Section 16 Planning Application for Proposed Temporary Warehouse (excluding Dangerous Goods Godown) and Open Storage of Construction Material and Machineries with Ancillary Facilities and Associated Filling of Land for a Period of 3 Years at Various Lots in D.D. 87 and Adjoining Government Land, Kong Nga Po, Sheung Shui, New Territories

Planning Application No. A/NE-FTA/264

Responses to Comments Table

Submission of Stormwater Drainage Proposal

Proposed Land Filling

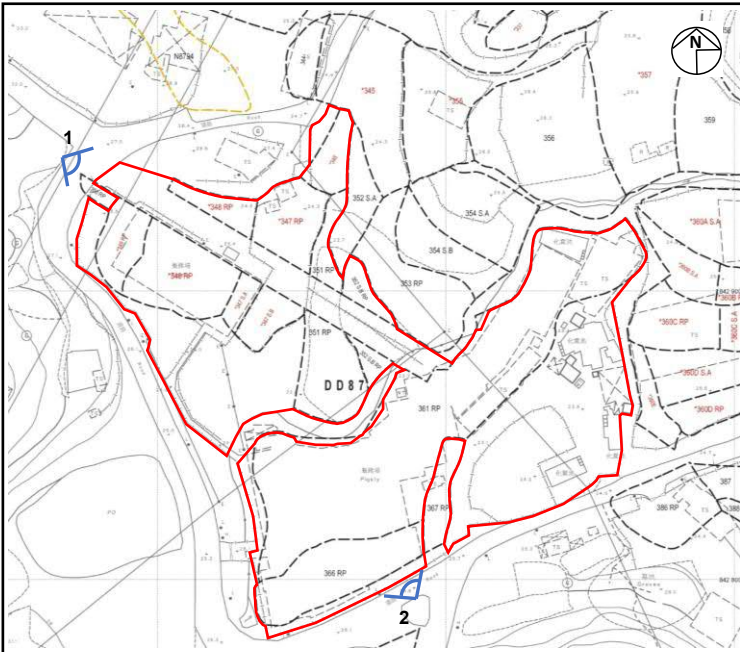
e) Filling plan of the Subject Site under the Drainage Proposal refers. Please advise whether substantial landfilling degrades or analyses the implication to the existing streamcourse and adjoining catchment areas. No land filling on site shall be allowed until the flood mitigation measures have been implemented to the satisfaction of DSD.	It is clarified that no substantial landfilling is involved in the current application. While it is stated that the depth of landfilling will not exceed 3m, it should be noted that the site level of the application site is significantly lower than the adjoining road. The proposed landfilling aims to align the site with road level to prevent flooding (Illustration 2 refers). In generally, site levels within the application are proposed to be raised by about 1 to 1.5 m to create a flat surface for the proposed use. The proposed levels will maintain a gradual decrease from the southwest to the northeast, and it is anticipated that rainwater will continue to flow from this direction to the river without significant changes. Please refer to Figure 4 of the Planning Statement. The drainage impact assessment also evaluates the drainage impact at proposed filling level and shows no adverse drainage impact.
